Product / Process Change Notification (PCN)	
<input checked="" type="checkbox"/> Major Change <input type="checkbox"/> Minor Change	
<p>PCN Number: PCN_IndHCC_20241226</p> <p>Affected Series: WE-HCC</p> <p>Affected Order Codes: See table 1</p> <p>PCN Date: 2024-09-26 (YYYY-MM-DD)</p> <p>Effective Date: 2024-12-26 (YYYY-MM-DD)</p>	<p>Change Category:</p> <p><input type="checkbox"/> Equipment/Location</p> <p><input type="checkbox"/> General Data</p> <p><input type="checkbox"/> Material</p> <p><input type="checkbox"/> Process</p> <p><input checked="" type="checkbox"/> Product Design</p> <p><input type="checkbox"/> Shipping/Packaging</p> <p><input type="checkbox"/> Supplier</p> <p><input type="checkbox"/> Software</p>
<p>Contact: Product Management</p> <p>Phone: +49 (0) 7942 - 945 5001</p> <p>Fax: +49 (0) 7942 - 945 5179</p> <p>E-Mail: pcn.eisos@we-online.com</p>	<p>Datasheet Change:</p> <p><input checked="" type="checkbox"/> Yes <input type="checkbox"/> No</p> <p>Attachment:</p> <p><input type="checkbox"/> Yes <input checked="" type="checkbox"/> No</p>

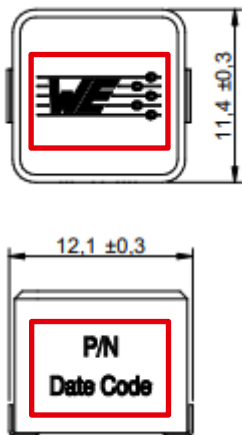
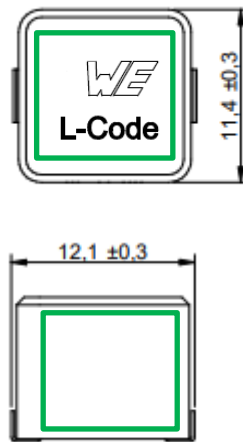
1. Würth Elektronik eiSos will improve the marking technology from the actual pad printing and inject methodology to the new laser methodology. With this change, Würth Elektronik eiSos will remove the date code on the side of the component for the order codes shown in the table 1.

Before Change	After Change

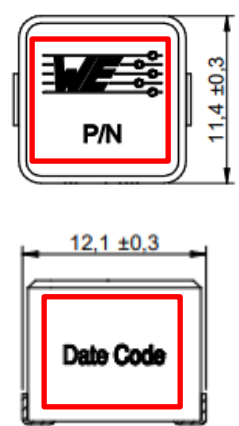
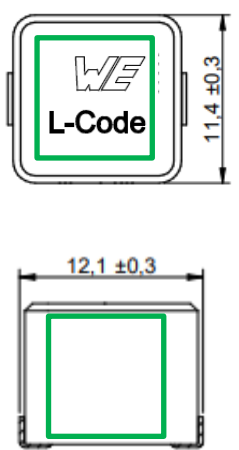
2. With the improvement in the marking technology, Würth Elektronik eiSos will update the drawings specifications accordingly to notify customer the new marking style used on the component for the order codes shown in the table 1.

2.1. For the sizes 8070, 1090, 1210 ferrites, shown in the table 1, Würth Elektronik eiSos will make the following change:
